INCH-POUND
MIL-L-3661/63C
AMENDMENT 1
15 SEPTEMBER 2003

MILITARY SPECIFICATION SHEET

LAMPHOLDER, LIGHTS, INDICATOR (HOUSING), STYLE LH96

This amendment forms a part of MIL-L-3661/63C dated 25 October 1978 and is approved for use by all Departments and Agencies of the Department of Defense.

FIGURE 5. Midget screw lamp socket.

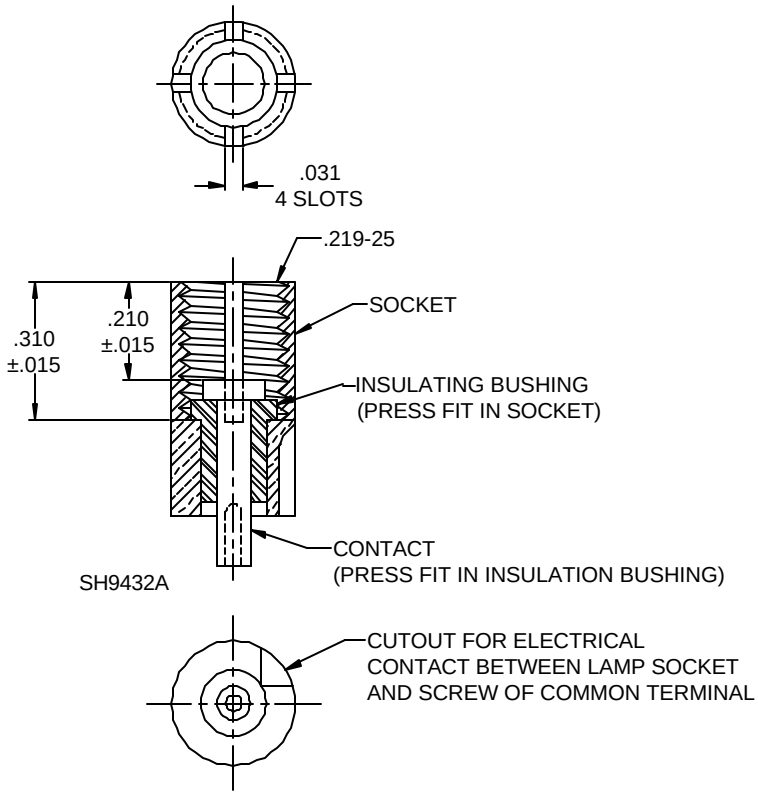
FIGURE 5: Delete and substitute:
